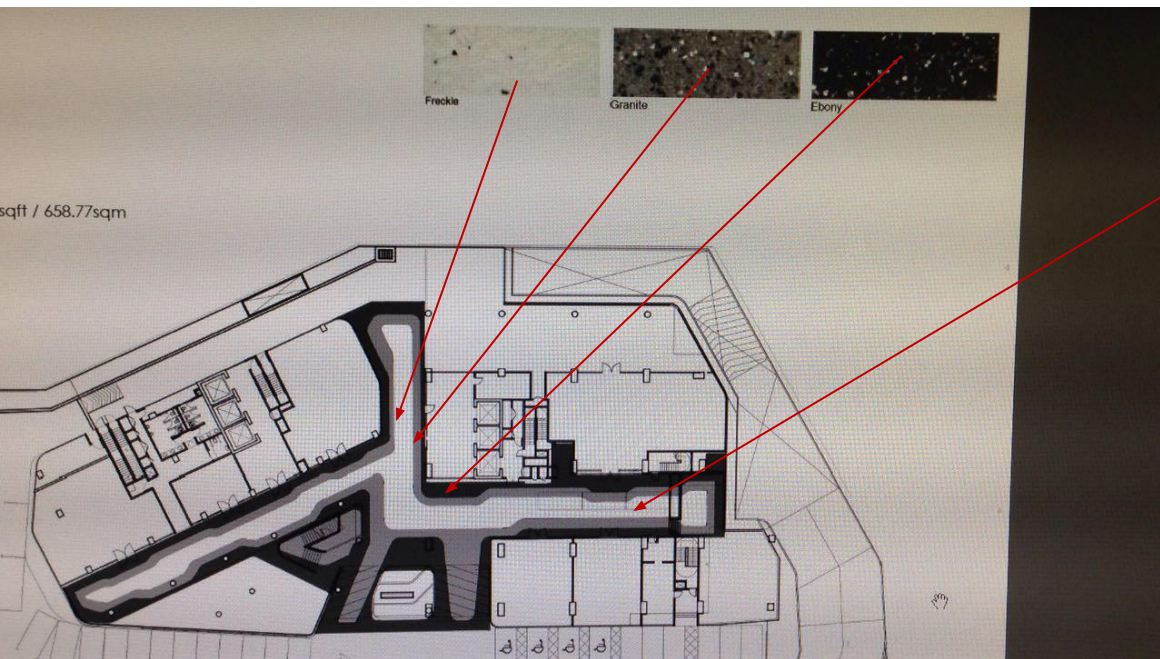
Why there has yellow patch?

No lighting at the bottom

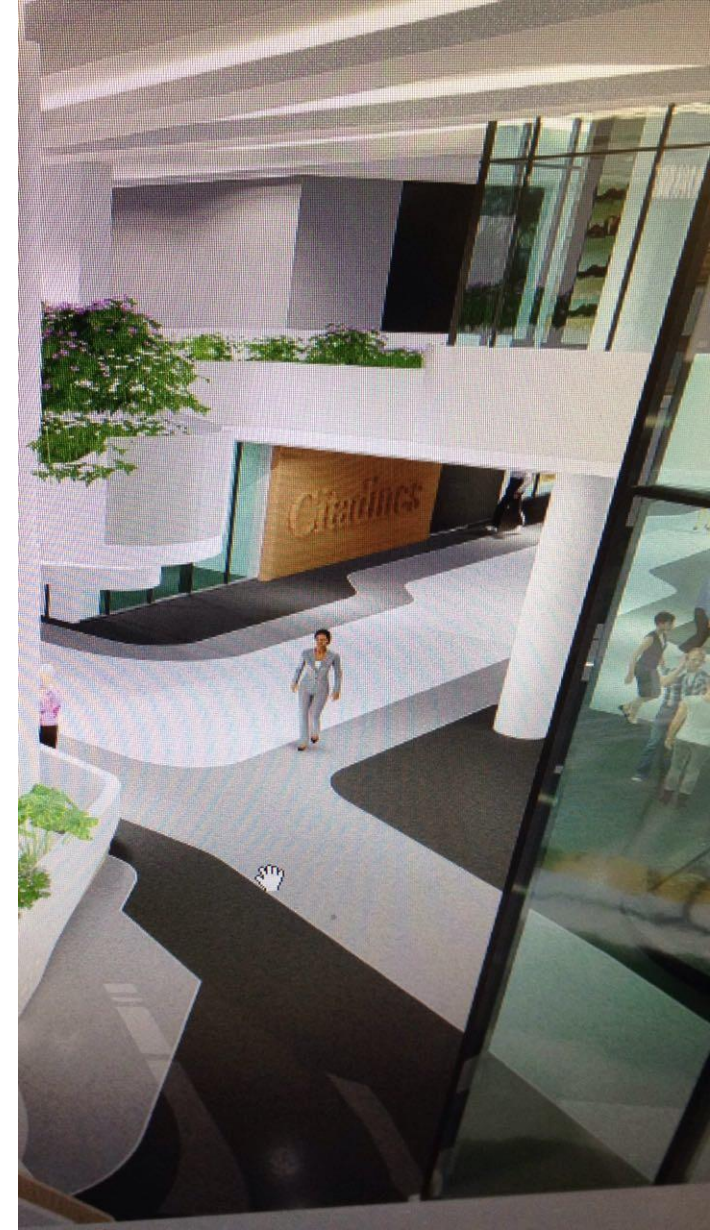
Floor pattern to follow

Light source to follow. More outdoor light

Recessed area in dark charcoal grey as per sketch up!

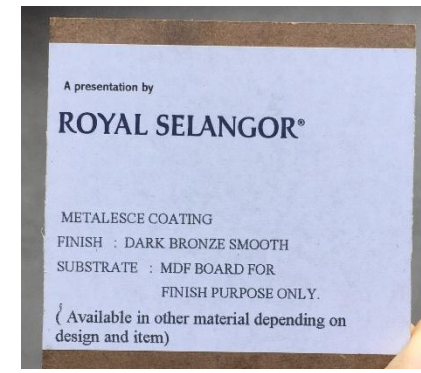
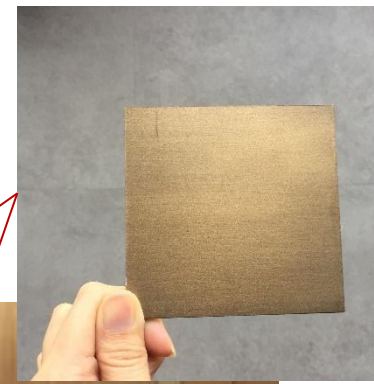
Glass door missing! To follow as per sketch up

Reception counter & "G" finishes

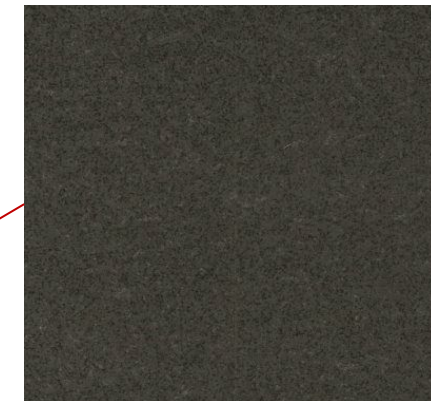
s/steel hairline Skirting missing!

300mm x 600mm tile in horizontal

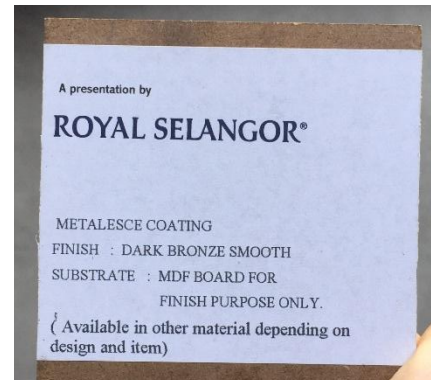
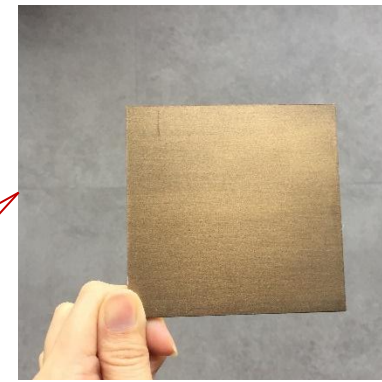
Lift car panel & lift frame & skirting to follow as per ground floor!
Pls have consistant and check within team before send out!

10mm Groove line still missing!

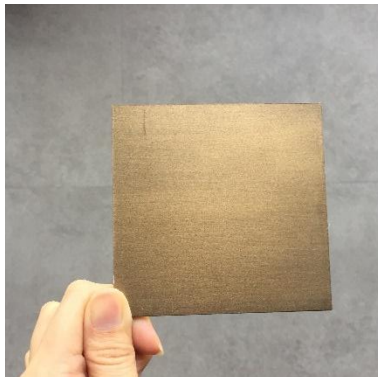
Can you guys see the lighting temperature is not consistently done?
Can all visuals to standardize as per Level 3 lift lobby??

Skirting in s/steel hairline finish

Units entrance signage to update
as per latest sketch up sent!!!!
Already commented on 170301 !!!

Cove light & down light
To on it!!!!

Deco panel & "3" signage finishes

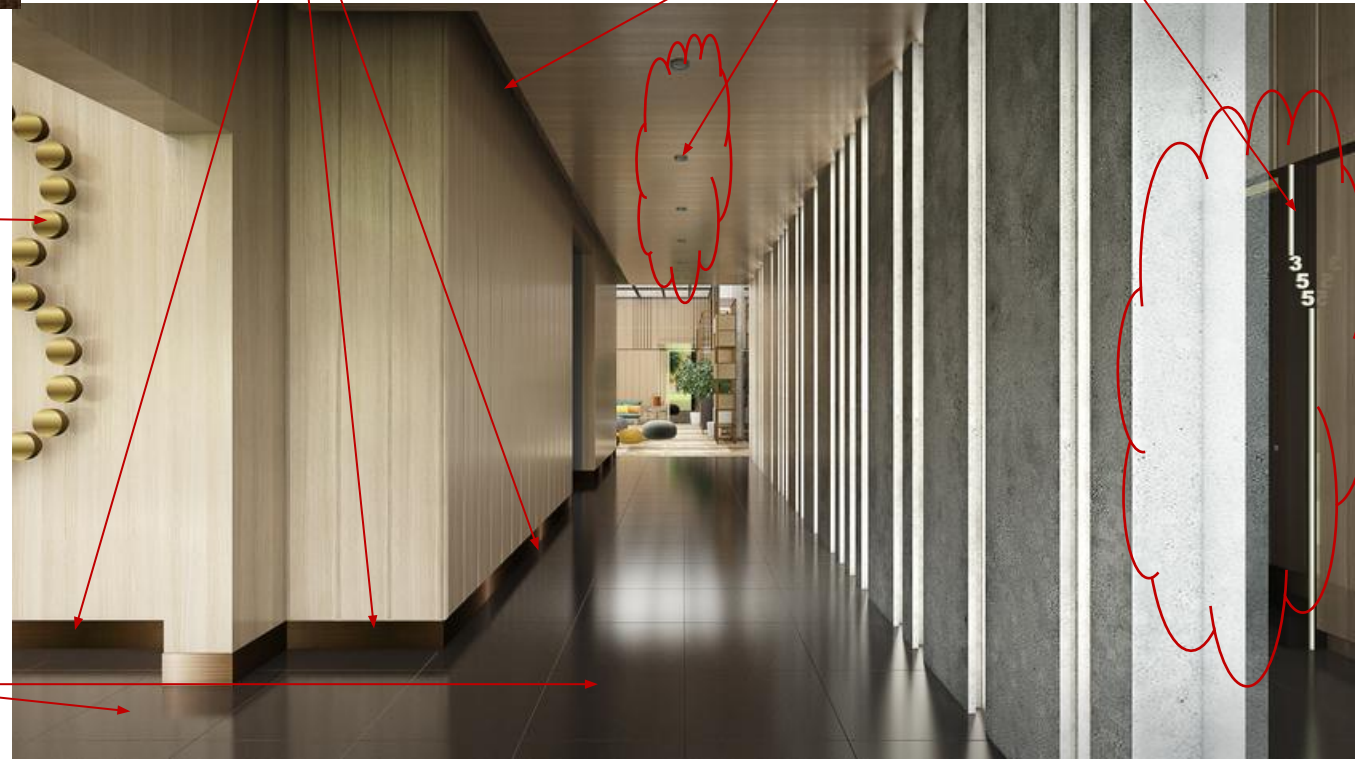
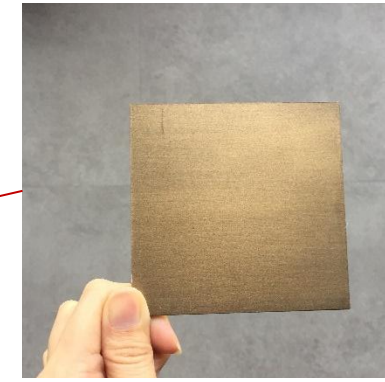
300mm x 600mm tile in matt finish lay horizontally.
To follow as per sketch red sent out previously!!!!

Reception counter finishes

Furniture arrangement still not follow as per sketch up!!!!!!

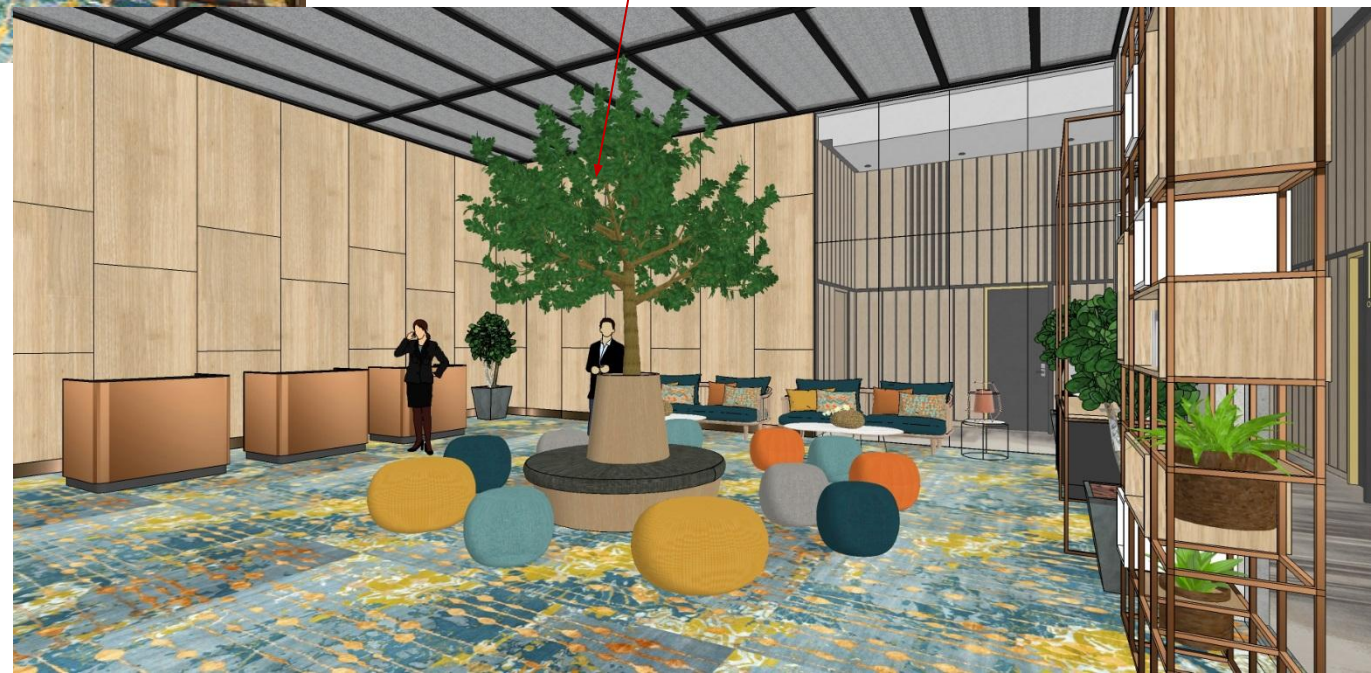
Plants to make it more volume as per sketch up!

Glass in grey tinted finish as per sketch up

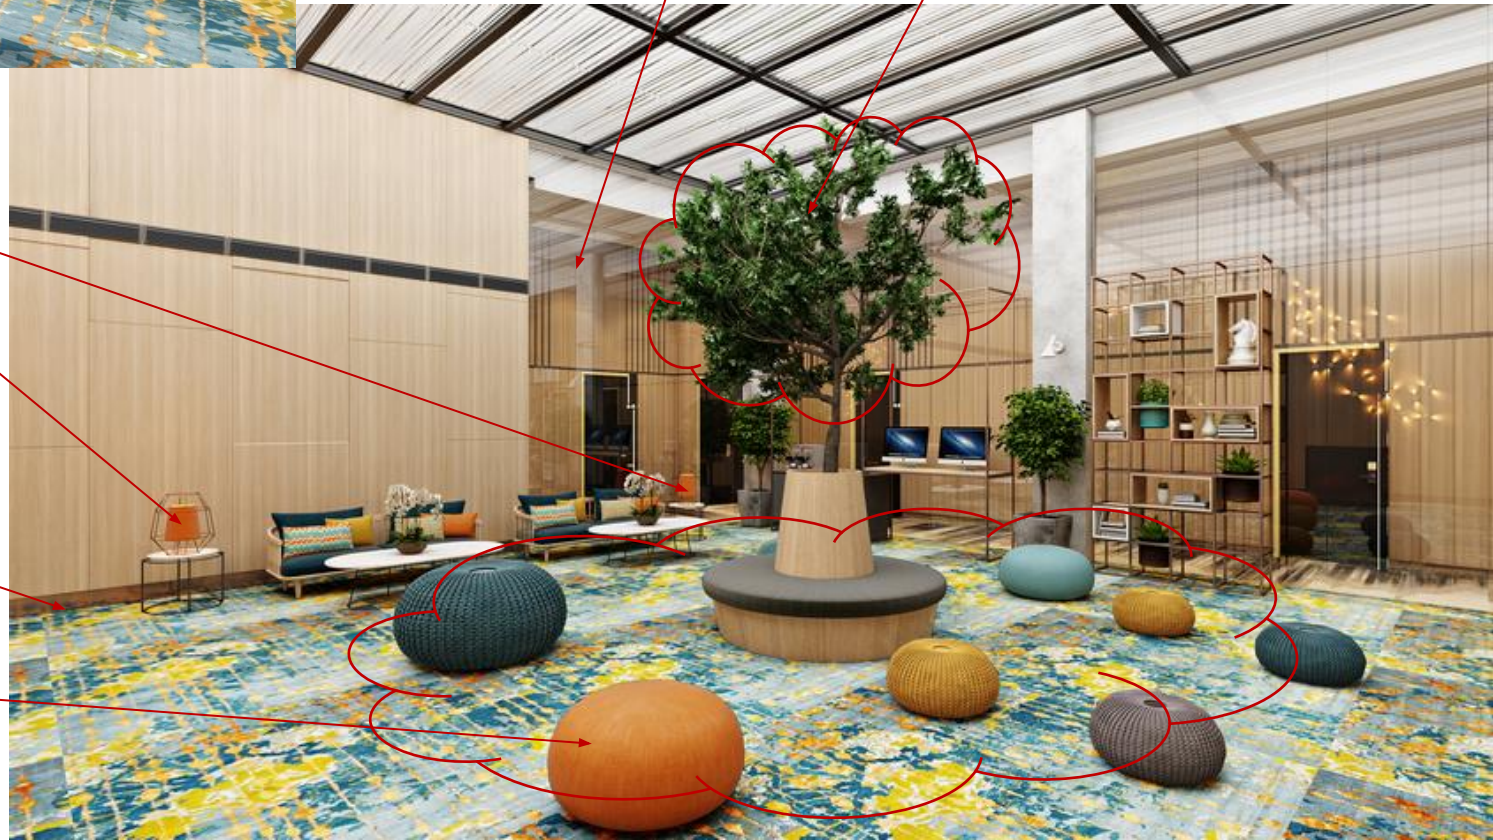
Plants to make it more volume as per sketch up!

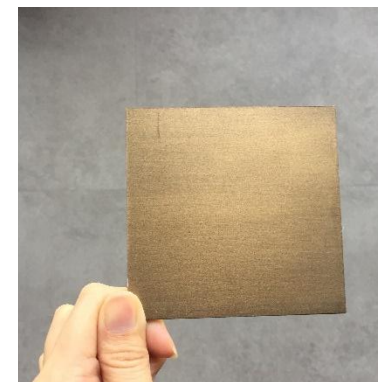
Interior light to on!

Skirting in s/steel hairline finish

Furniture scale & arrangement still not follow as per sketch up!!!!!!

Reception counter finishes

Light up the corridor

Not big tree at outdoor!
Same level as Level 3 lift lobby

Furniture scale & arrangement still
not follow as per sketch up!!!!!!

Lighting not consistent with other areas!!!!
So yellowish! Please do final check with team
before sent out!

Glass in grey tinted finish as per sketch up

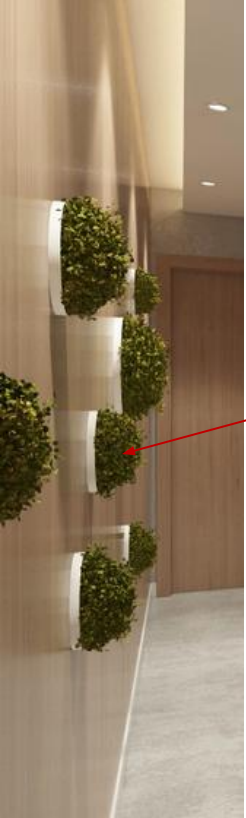
Light source temperature to have warm white as per level 3 lift lobby and to make sure all in consistent!
This lighting too white!

Plants selection to follow back as per previous!
Mirror correct!

No tree! Just sky view will do!

600mm x 600mm wall and floor tile.
Tile line missing

Make it brighter a bit. As per previous visual

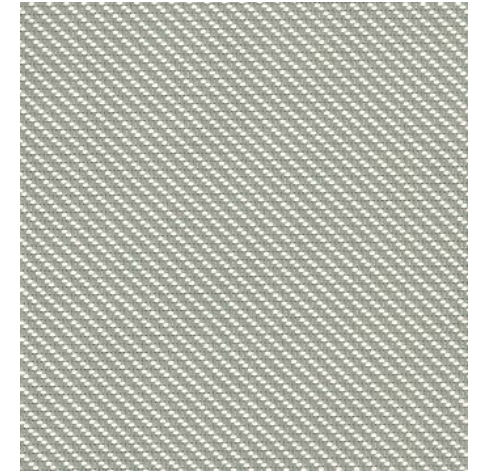
This is colour back glass! Pls show glass effect!!!!

Roller blind in light grey finish

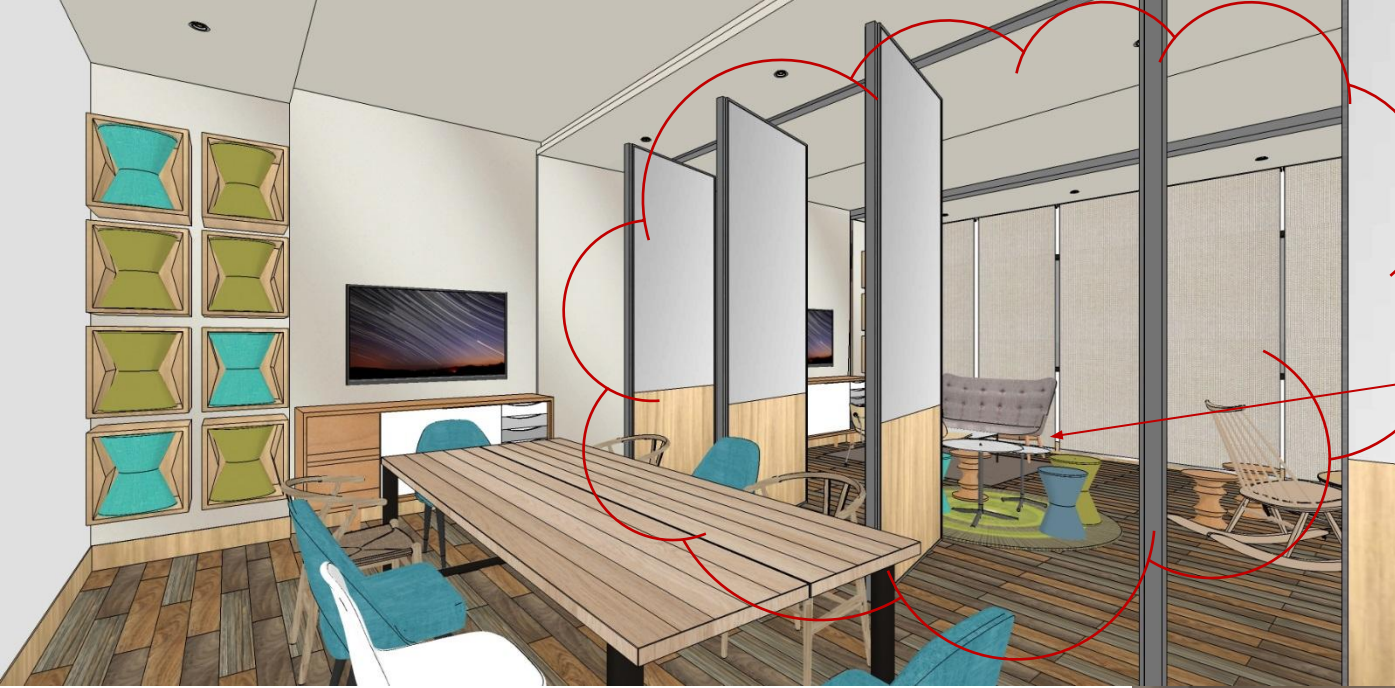
To follow as per sketch up!
To have view at another room

Chairs selection and arrangement
to follow as per sketch up
